SITE PLAN REVIEW AND APPEARANCE BOARD

---STAFF REPORT---

ITEM: 912 Palm Trail (2017-001) – Approval of a Class V Site Plan Modification and associated Landscape Plan, Architectural Elevations and Waiver request

SITE PLAN
NORTH
PARCEL

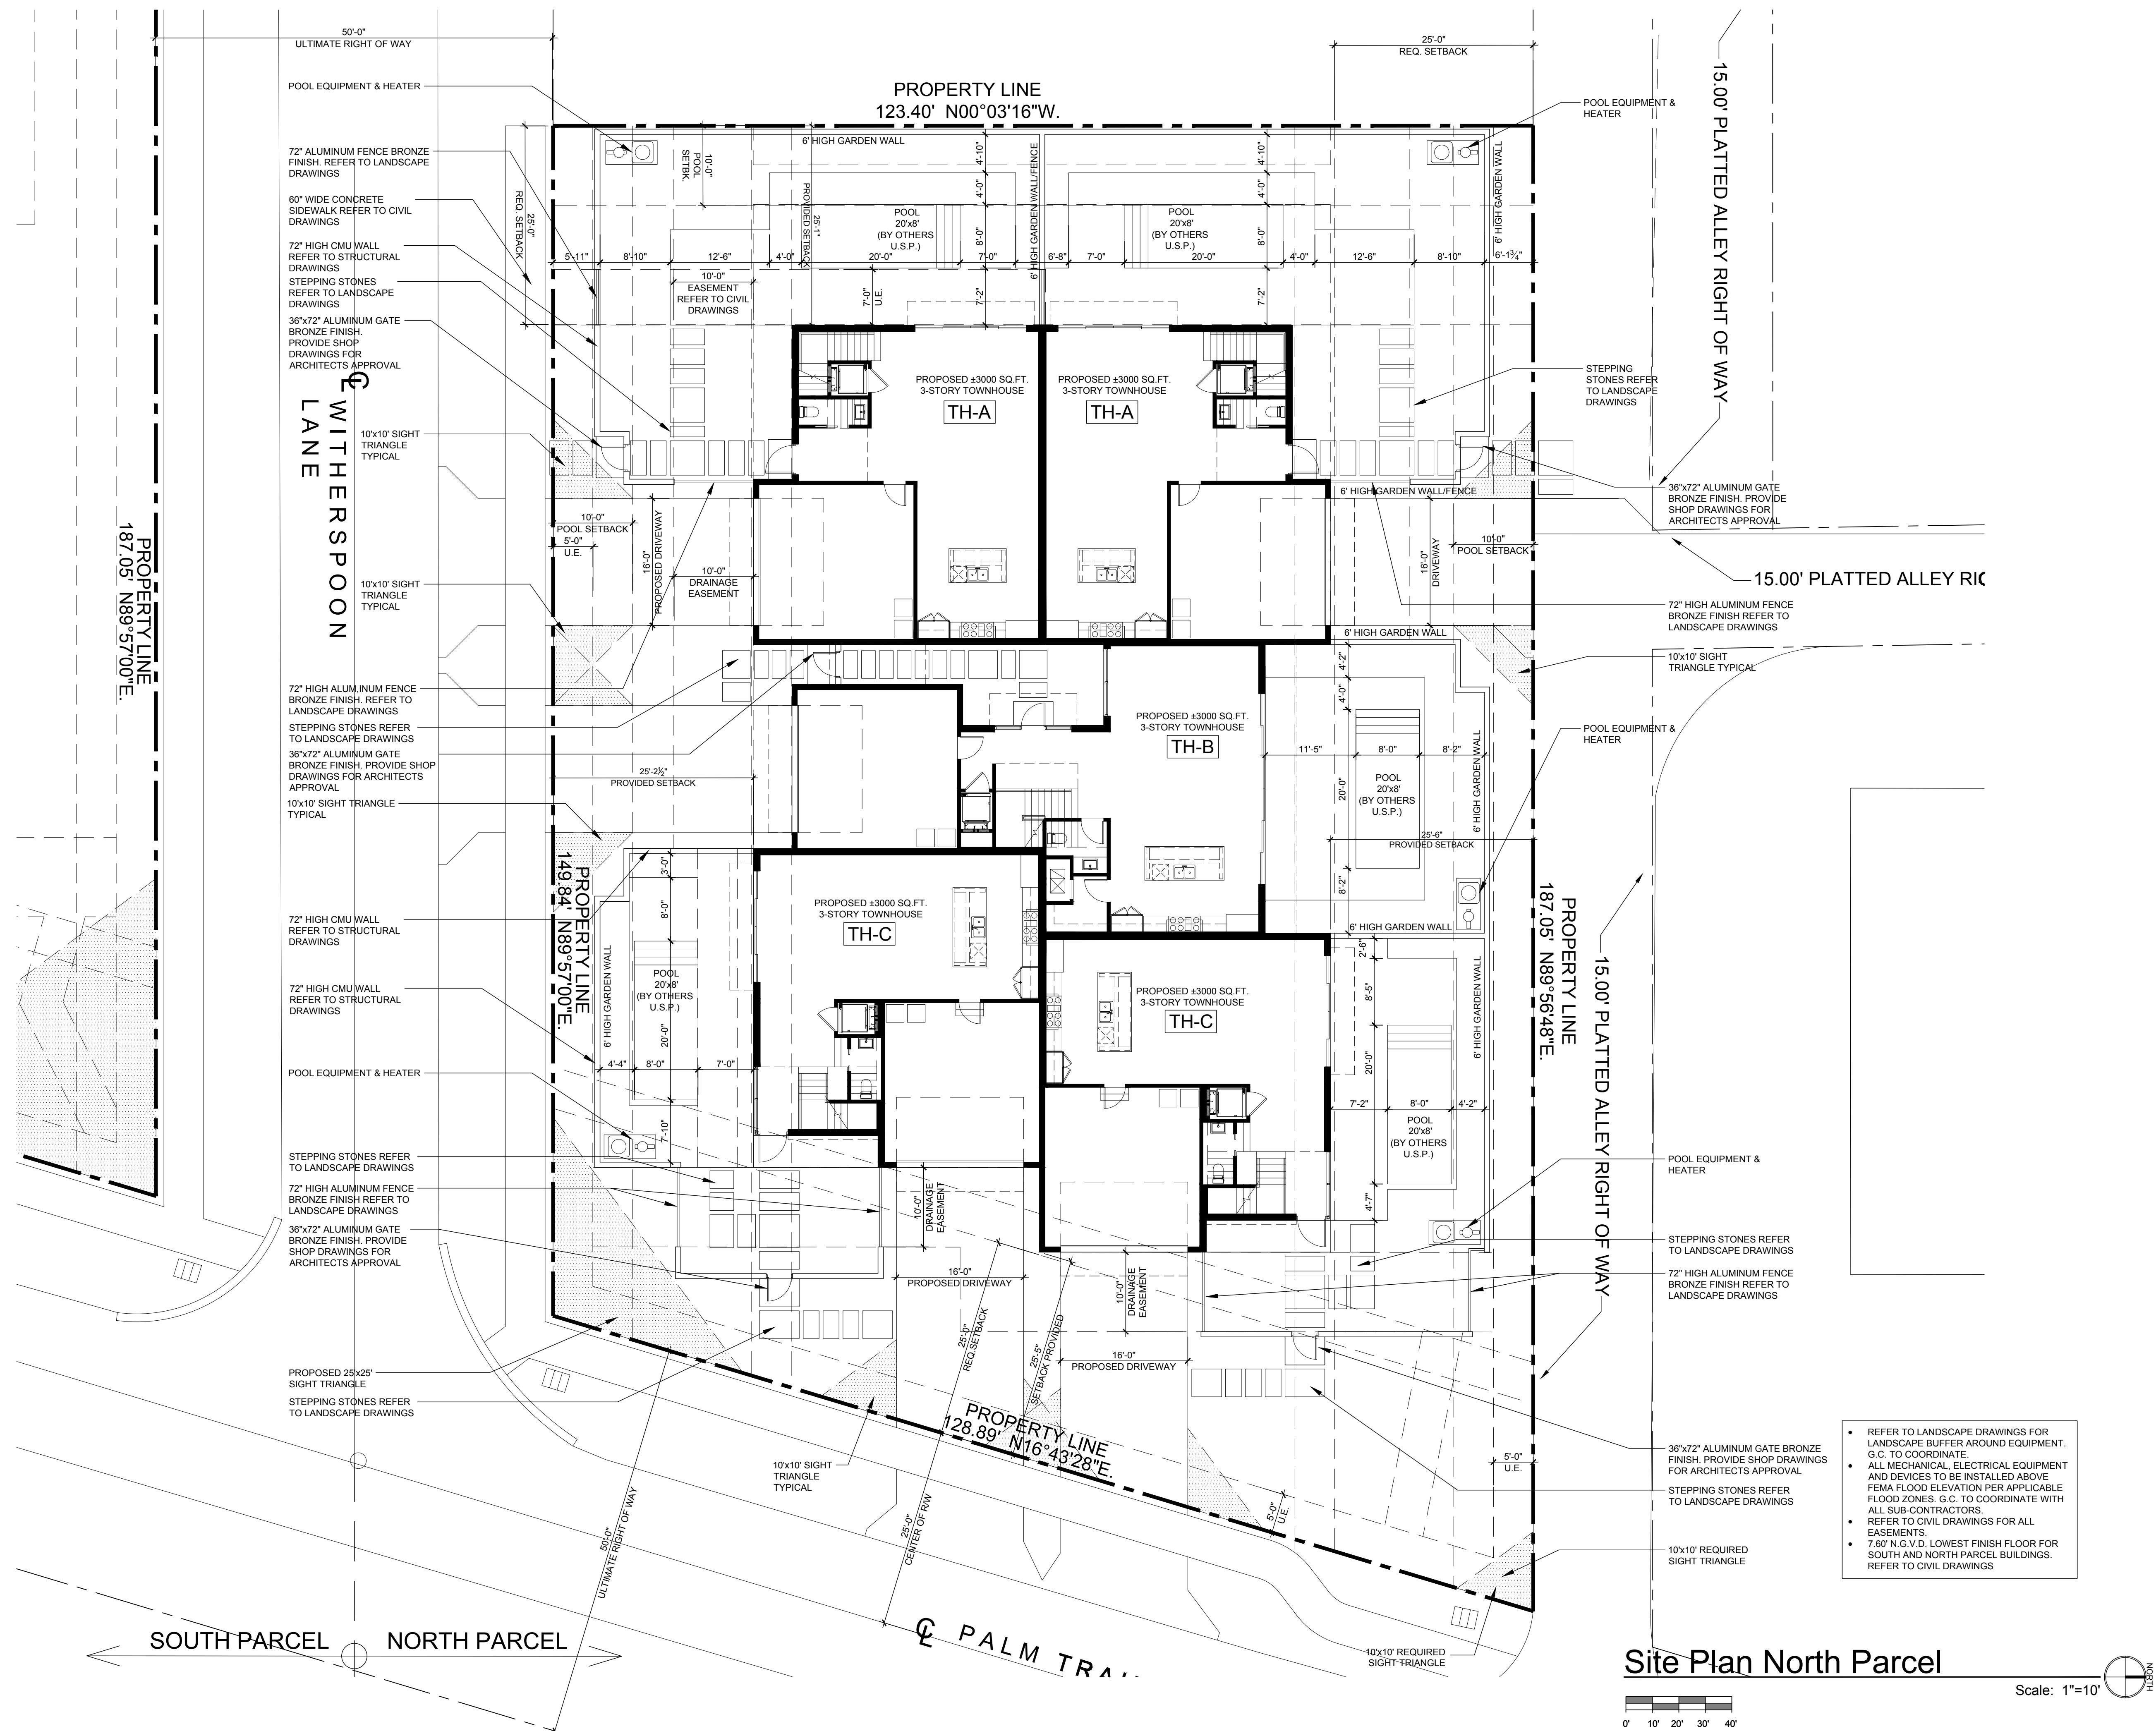
The north parcel intersects an alley way in which only a 10' sight visibility is shown on Palm Trail. As a condition of approval, the plans must indicate a 20' sight visibility on Palm Trail prior to certification.
